TECHNICAL BULLETIN

File No.:	TB-9711	Date:	01-30-97
Model:	FT-1000MP	Serial No. Range:	Problem Units

Problem:	1.8mhz Band spurious problem
----------	------------------------------

Local Unit

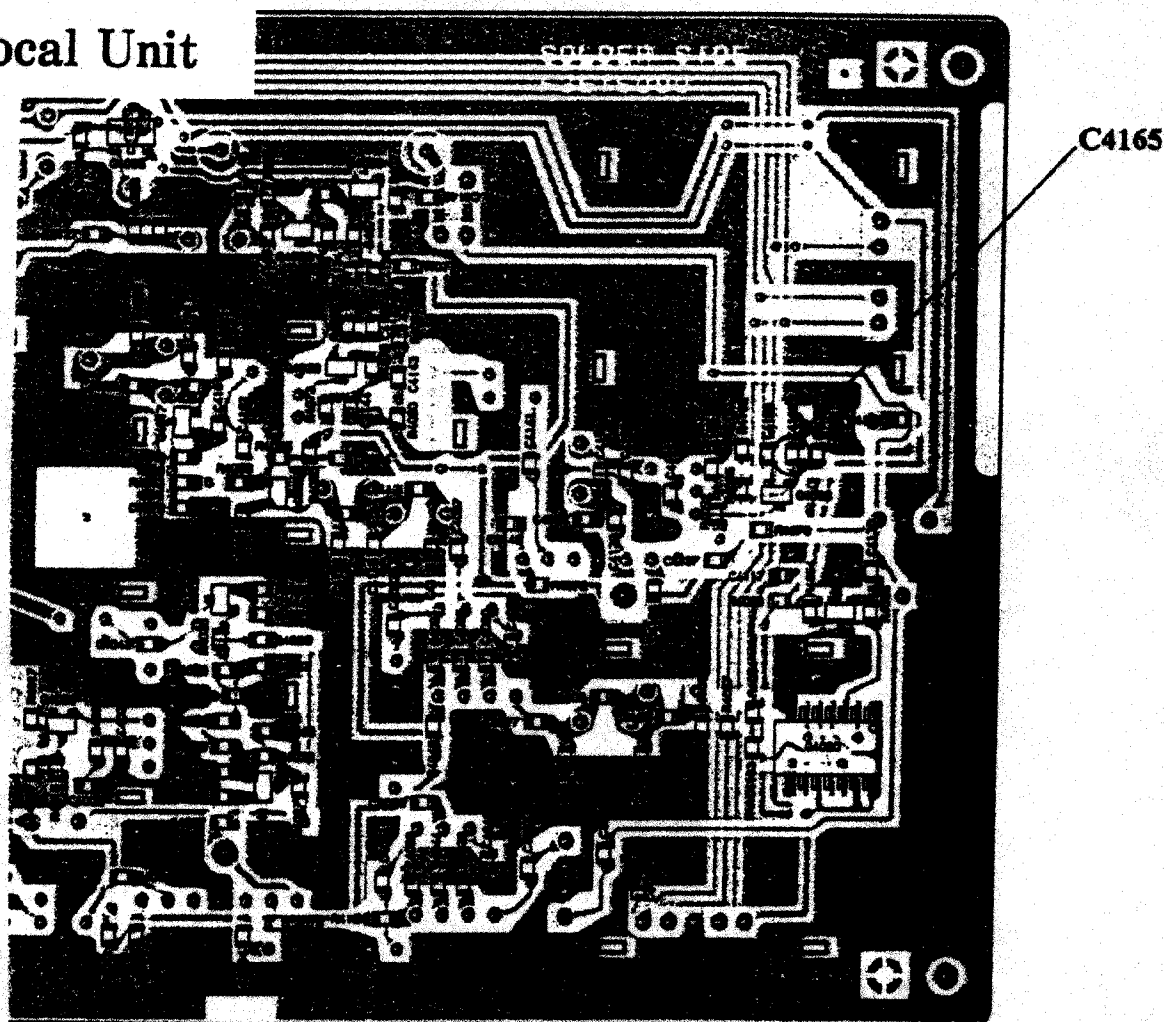
Expected Results of Modification:	Improve cross spurious problem on 1.8MHz
-----------------------------------	--

Component Value Changes: Local Unit		
Part Location No.	From	To
C4165	39pf K22170225 GRM40CH390J50PT	100pf K22170235 GRM40CH101J50PT
